STATE OF MAINE
DEPARTMENT OF TRANSPORTATION
16 STATE HOUSE STATION
AUGUSTA, MAINE 04333-0016

January 22, 2018
Subject: Billings Bridge
Superstructure Replacement
State WIN: 022618.00
Location: **Paris**
Amendment No. 2

TERMINAL CURB DETAIL
Sta. 100+43.4 to Sta. 100+58.0, RT
Sta. 100+52.9 to Sta. 100+68.4, LT
* Sta. 100+99.0 to Sta. 101+11.4 LT

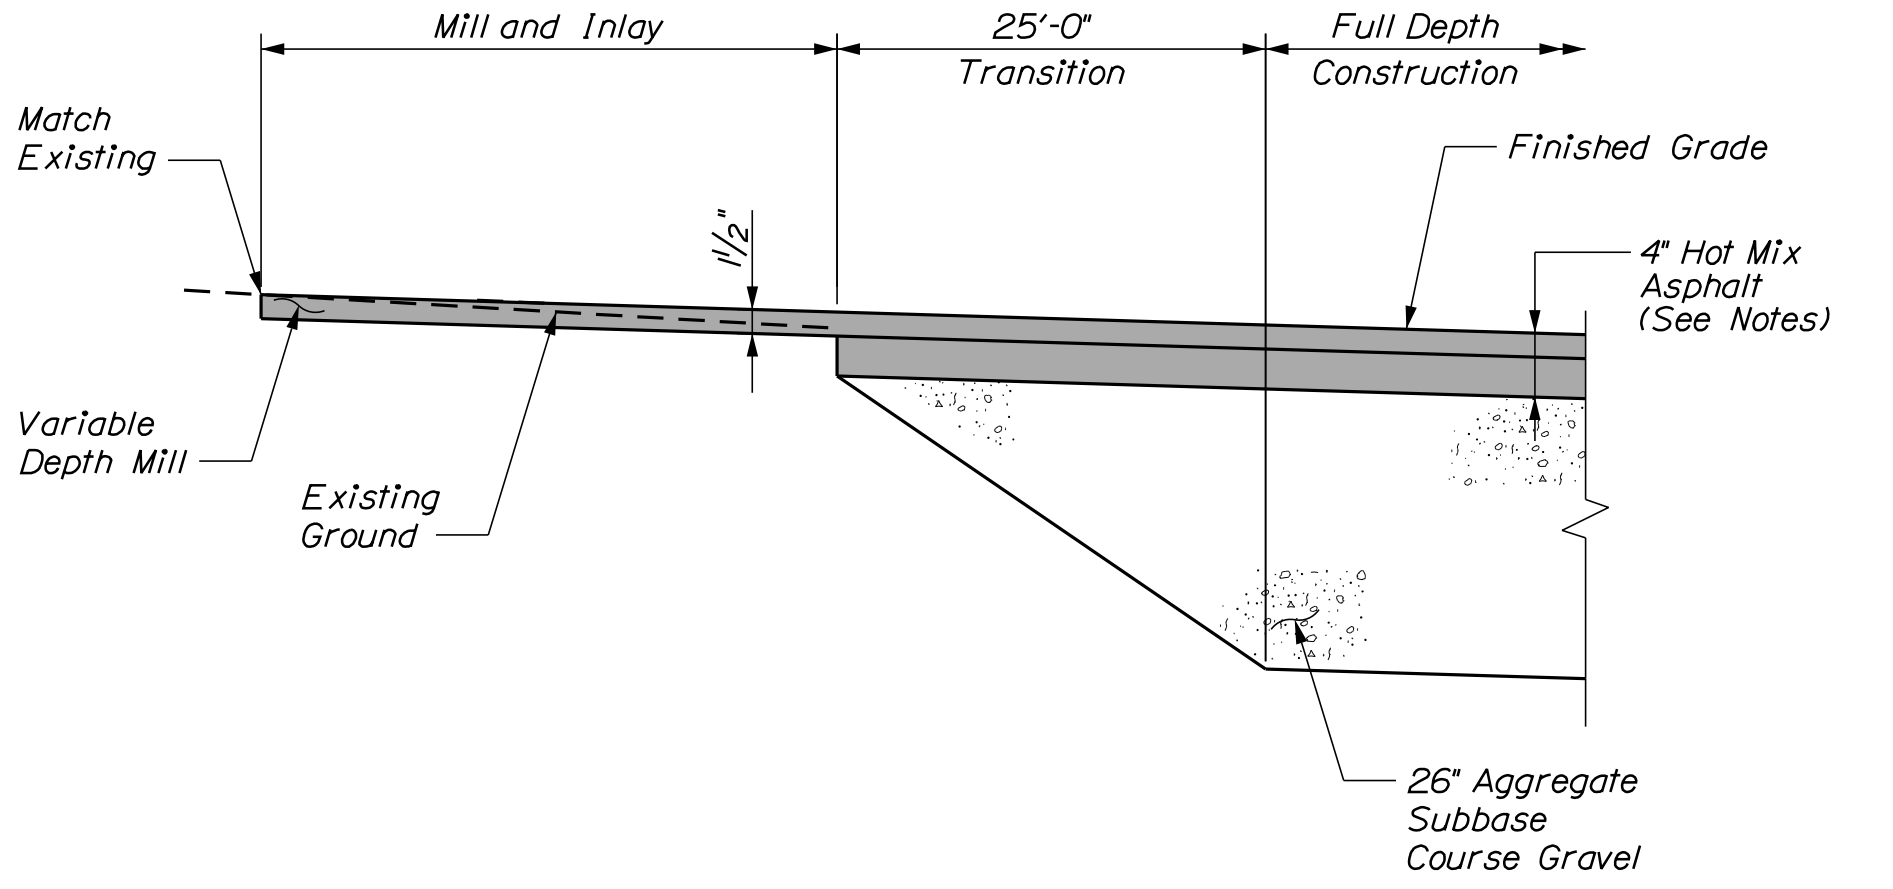
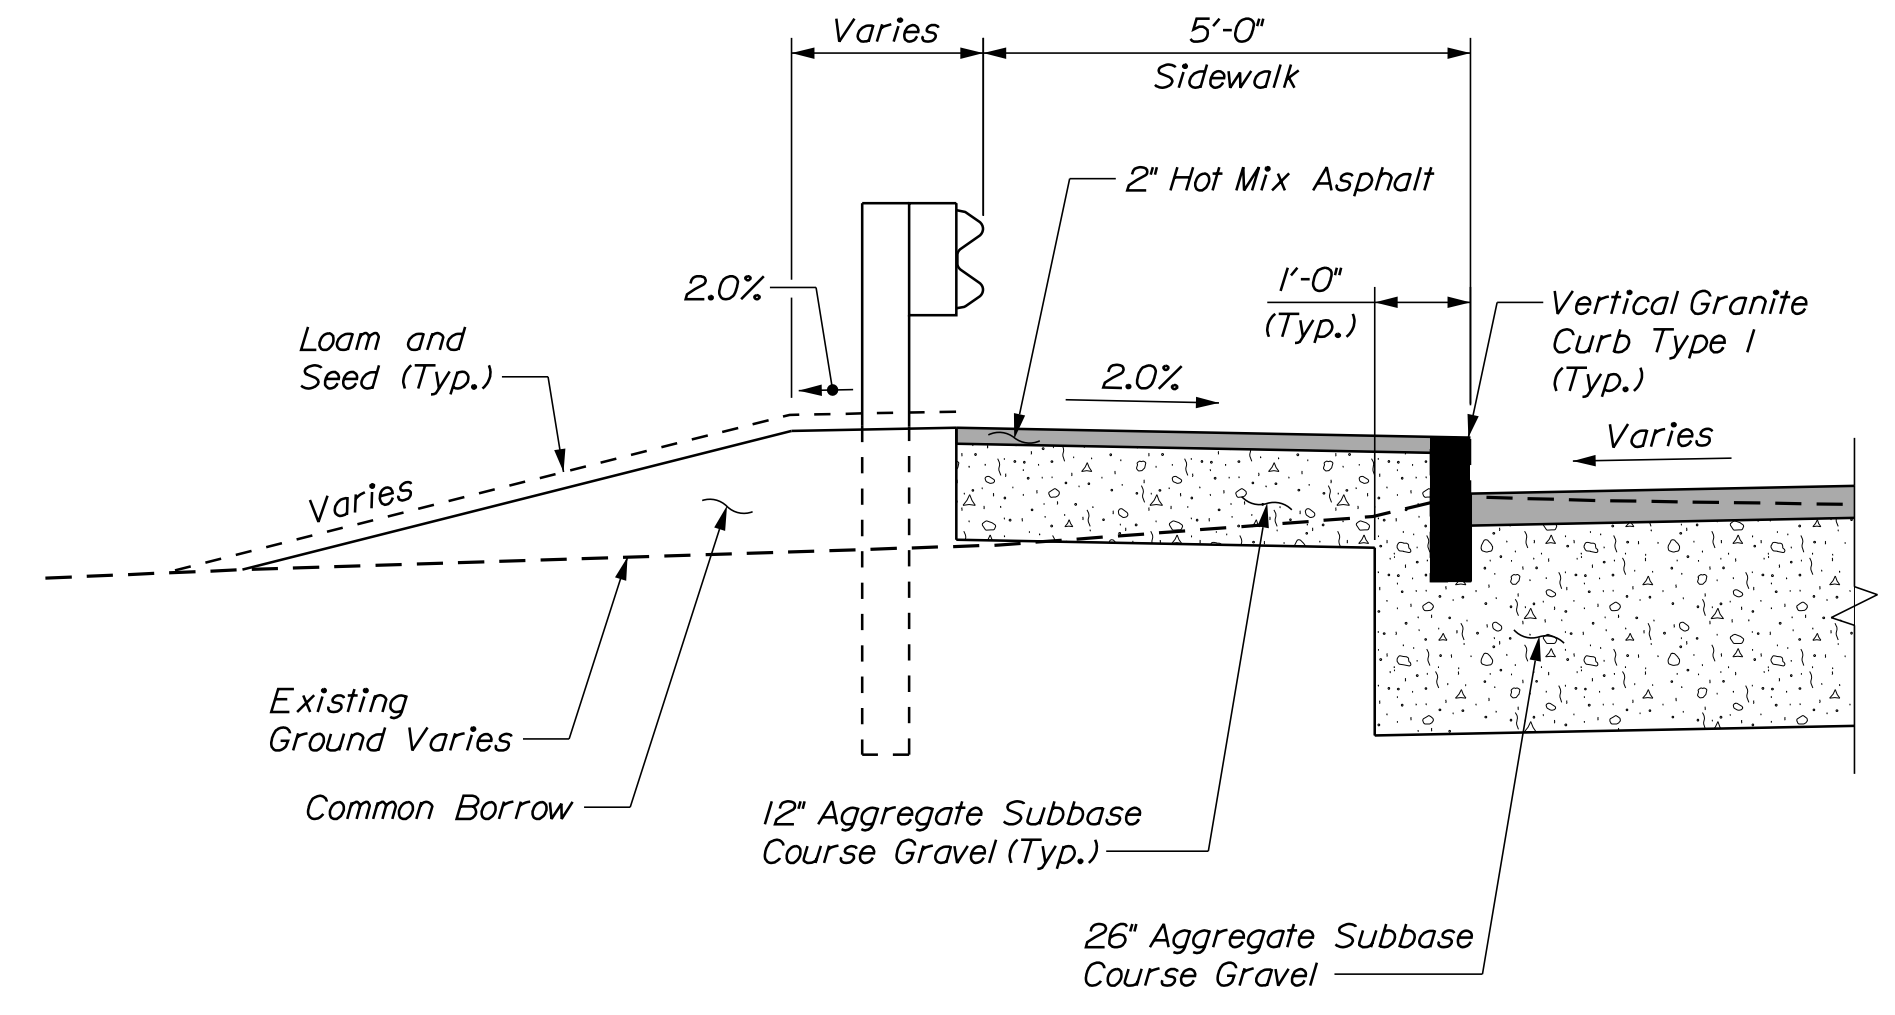
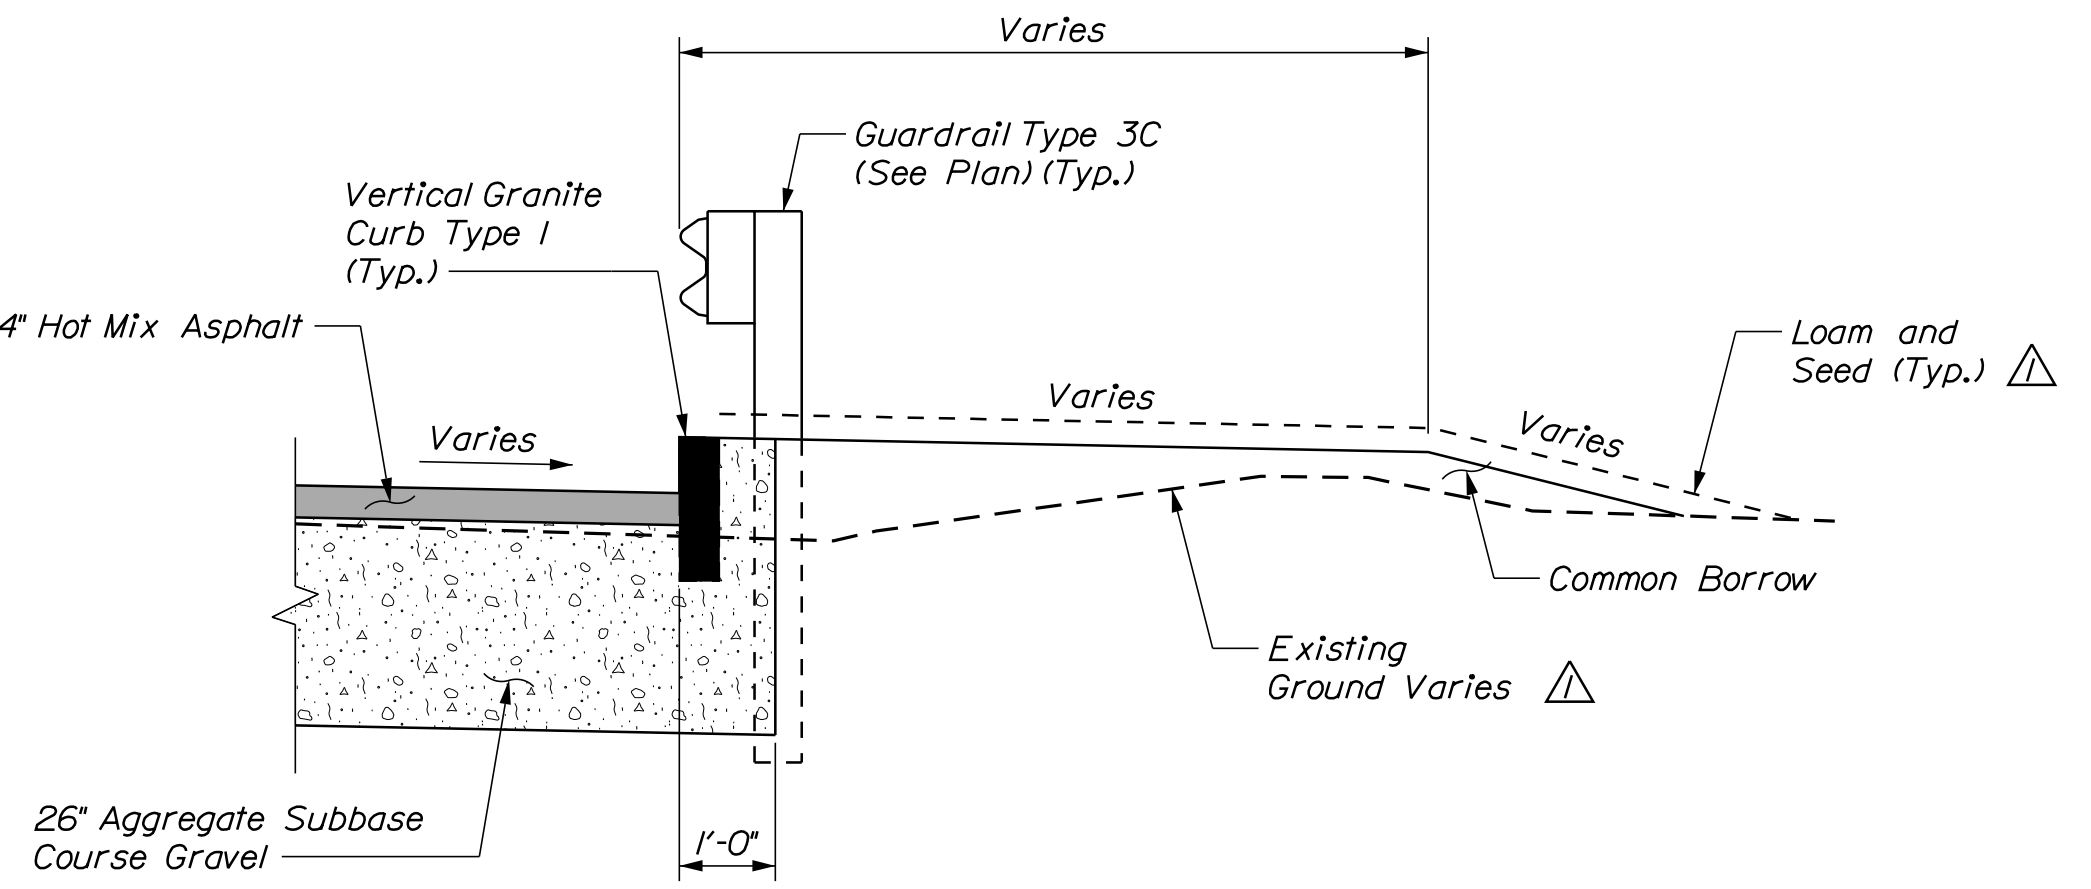
Question: Sheet 5 of 57 indicates mill and overlay from STA 99+60 to 100+35 and 105+50 to 105+75, but there is no bid item 202.202. Is there milling on the project, and if so could an item be added?

Response: Please see the attached, revised Proposal Schedule of Items.
